SUBJECT: Invitation for Bid #11-2872DC  
North Water Reclamation Facility Expansion 1                      ADDENDUM #1

**NWRF Expansion Phase I  
County Project No. 6011283  
ADDENDUM 1  
November 3, 2011**

**CHANGES TO THE DRAWINGS**

EFFLUENT PUMP STATION

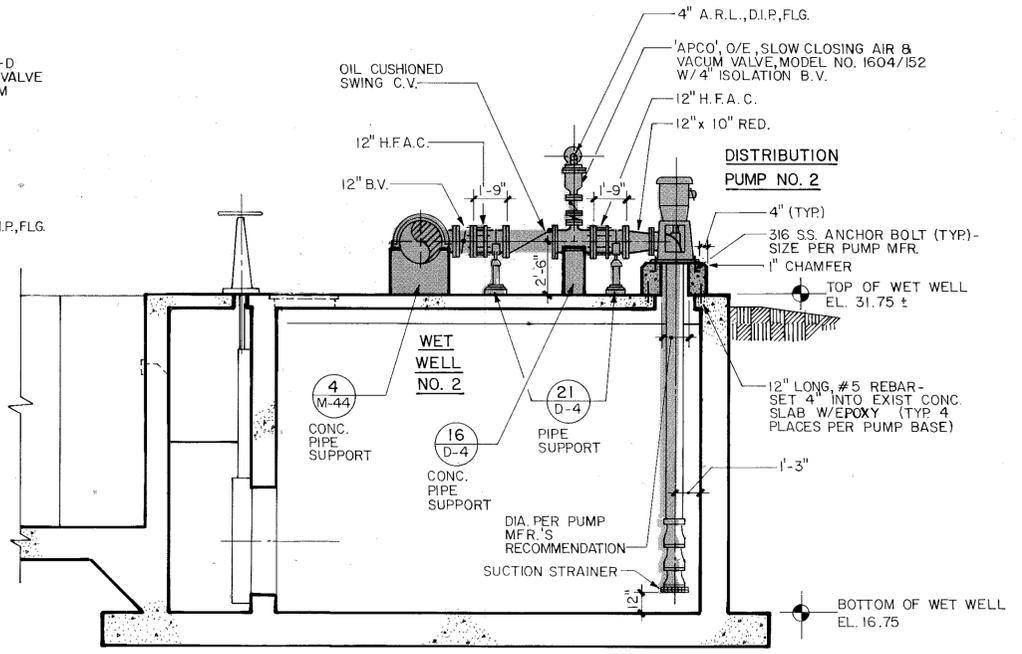
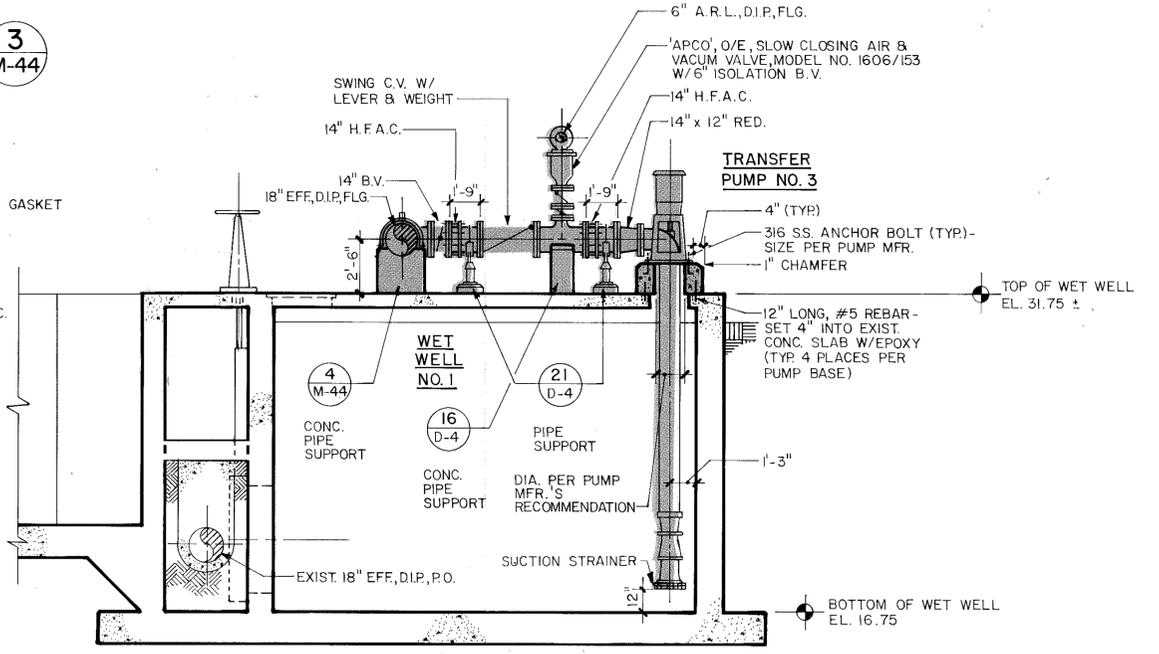
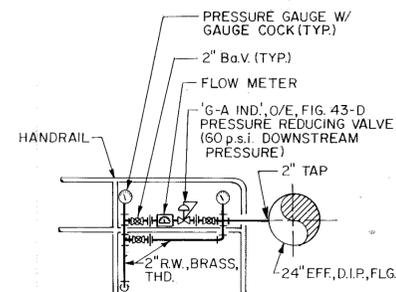
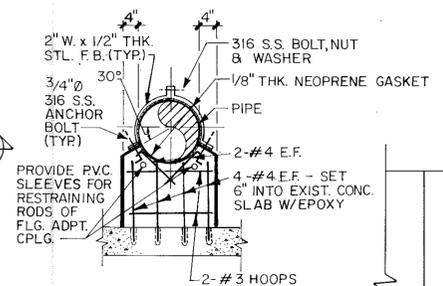
21. Is there adequate room within the Effluent PS to not have interference with the existing pump on the north end of the structure to install the bends? **The location of the 30" tee and associate piping, valves and fittings should be shifted west to avoid a conflict. Final location shall be coordinated with Owner and Engineer prior to work.**

22. Can as-built drawings be provided for the Effluent PS interior? **See Record Drawing Sheet M-44 attached to this addendum.**
23. Can the top slab of the Plant Drain Pump Station be cut outside of the valve vault and wet-well then replace these sections with a new slab rather than having to support the slab while replacing the piping below the top slab? **The top slab of the Plant Drain Pump Station cannot be cut outside of the Valve Vault and Wet-Well and replaced w/ sections of new slab. Unfortunately the existing drawings indicate the dowels from the Valve Vault & Wet Well walls to the existing slab were not placed so that the horizontal leg of these dowels would be positioned in the slab to facilitate this option.**

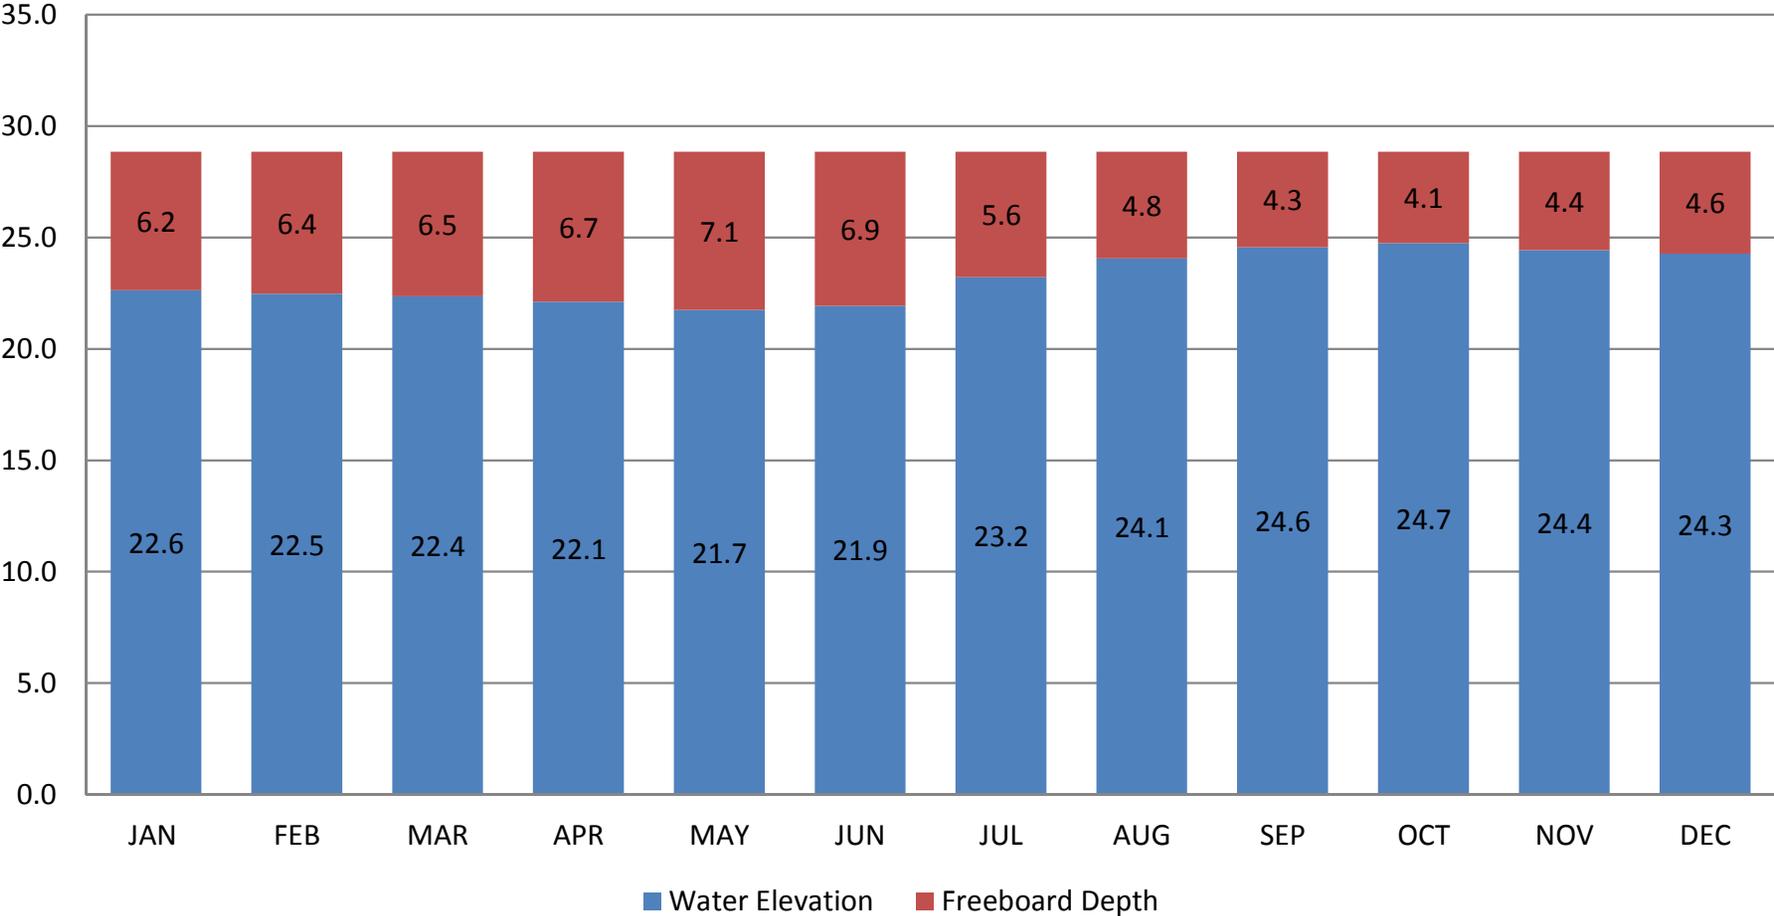
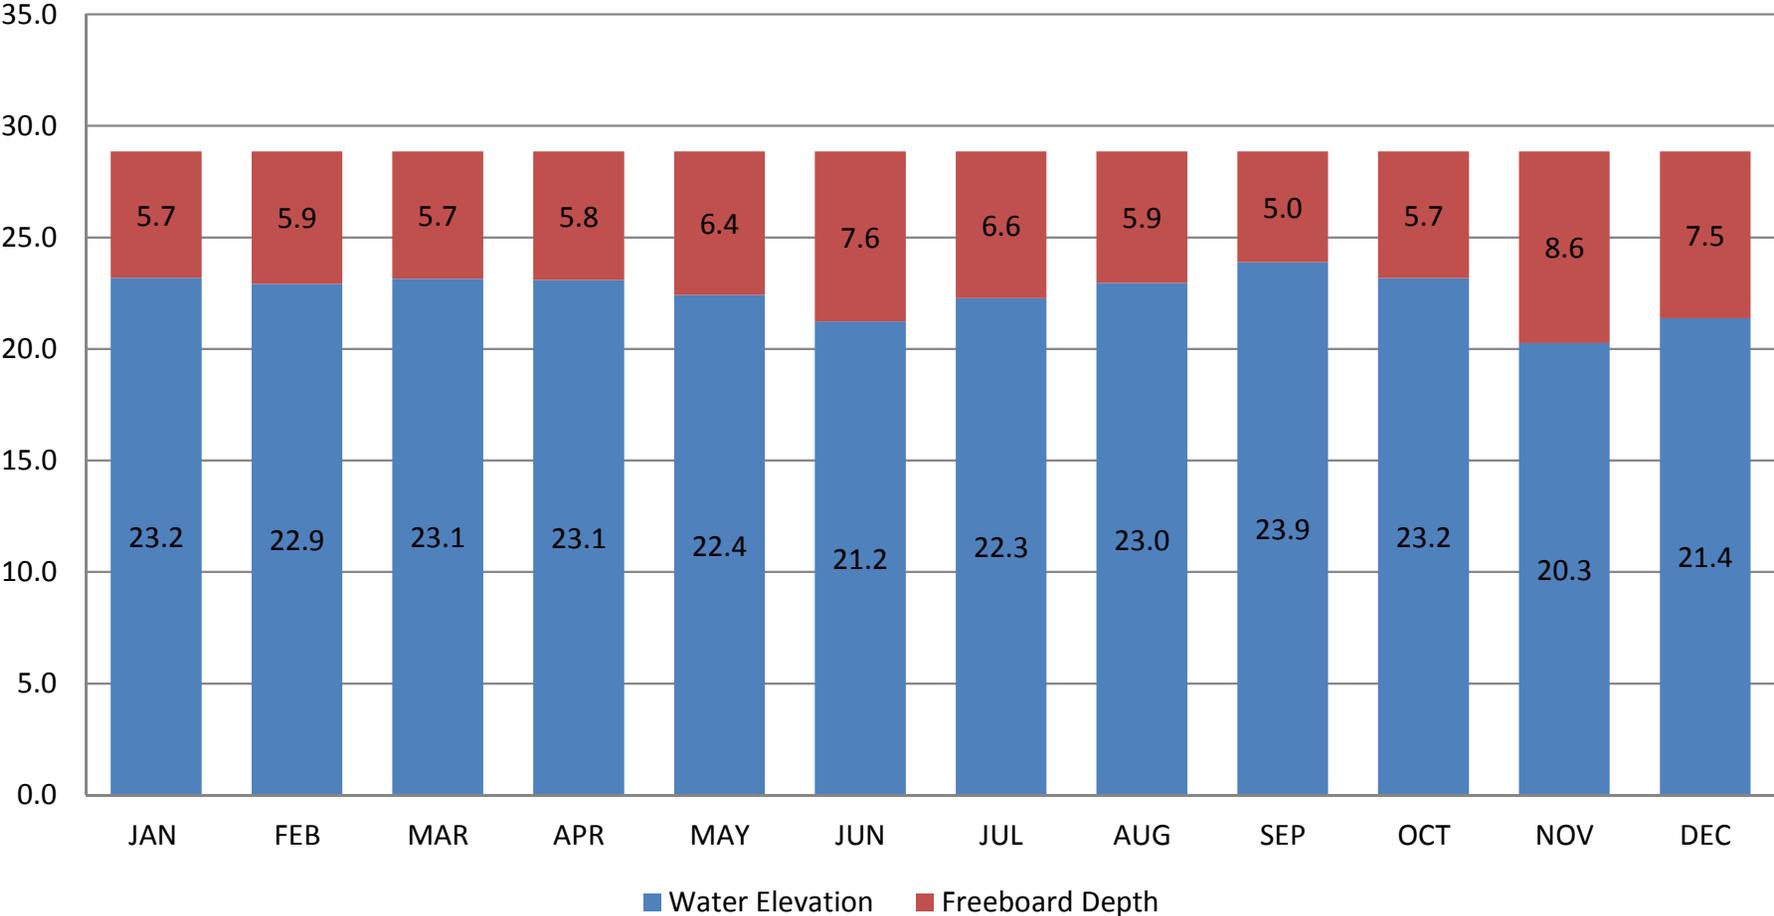
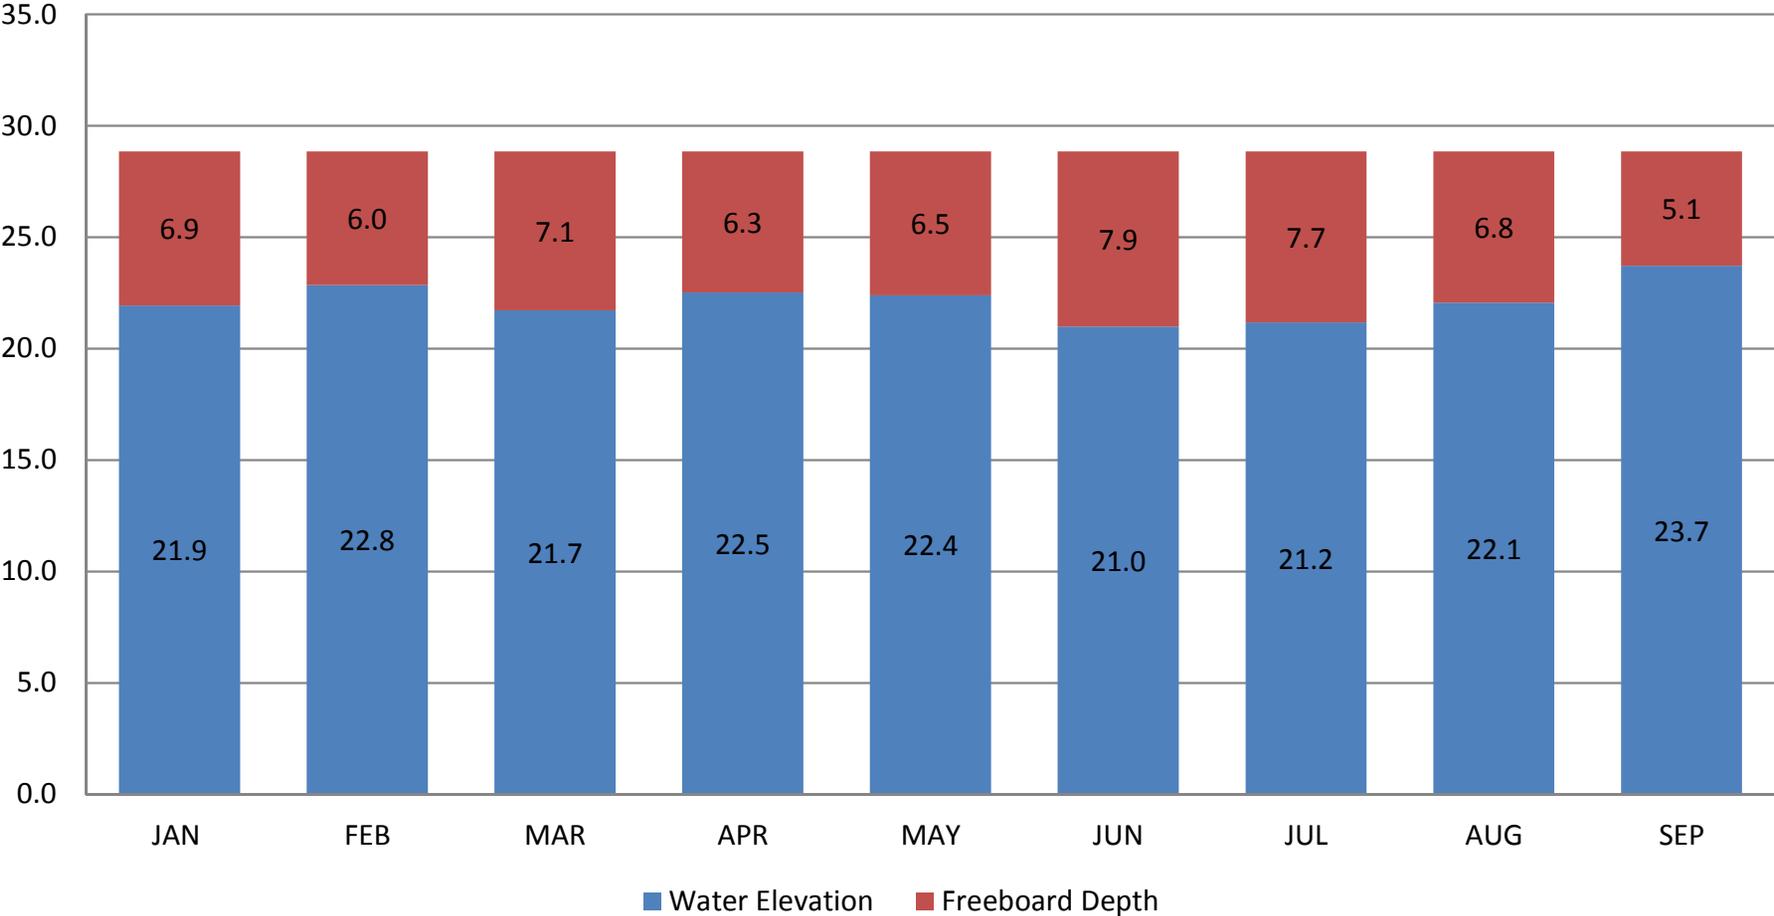
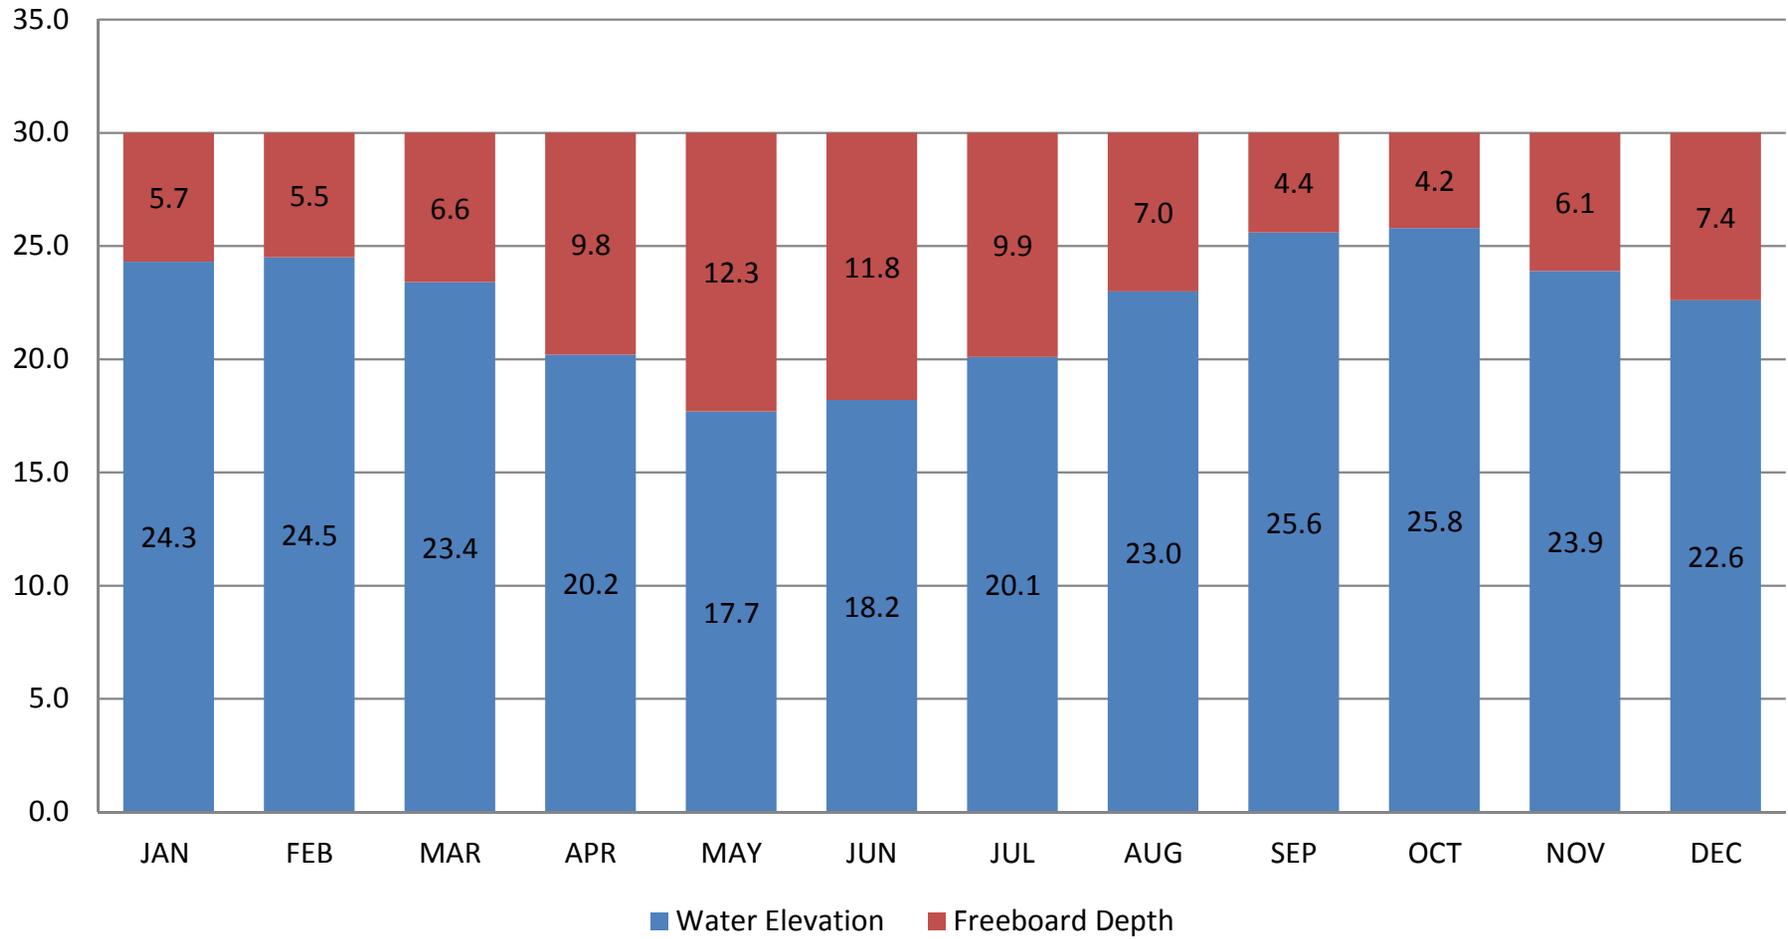
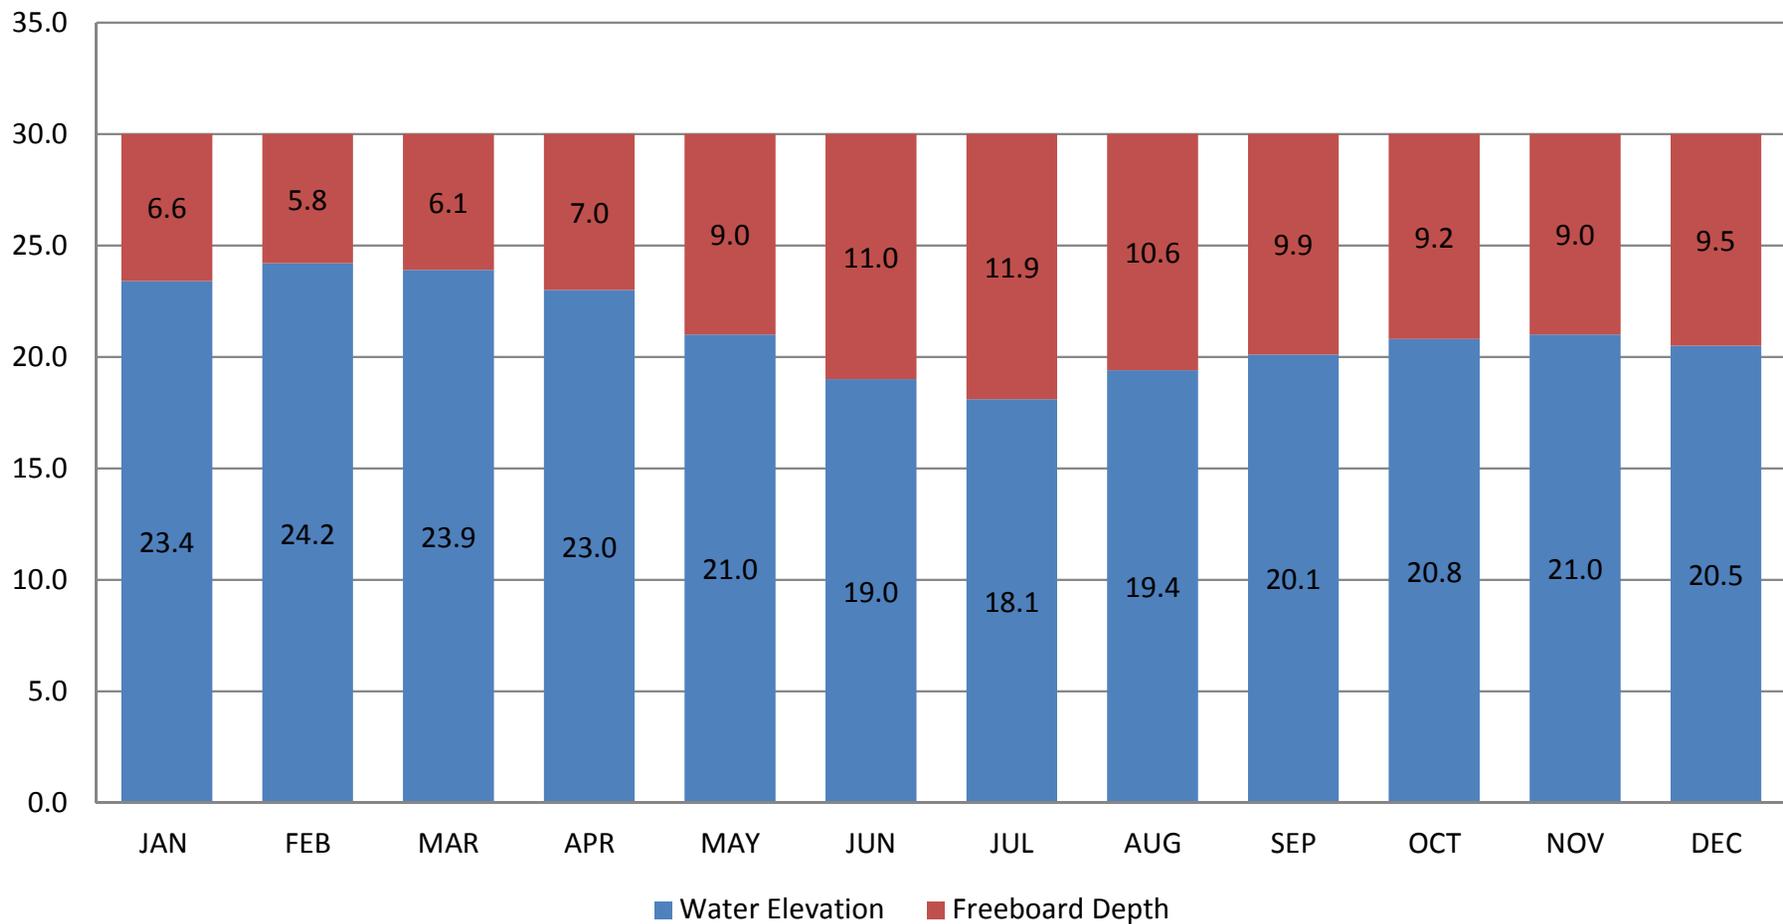
25. Can water level elevations in each lake be provided for a minimum of a year? **Historical Water Levels available for the East Lake and the Golf Course Lake are show in graphical form and attached to this Addendum. It should be noted that this is no guarantee of future conditions.**
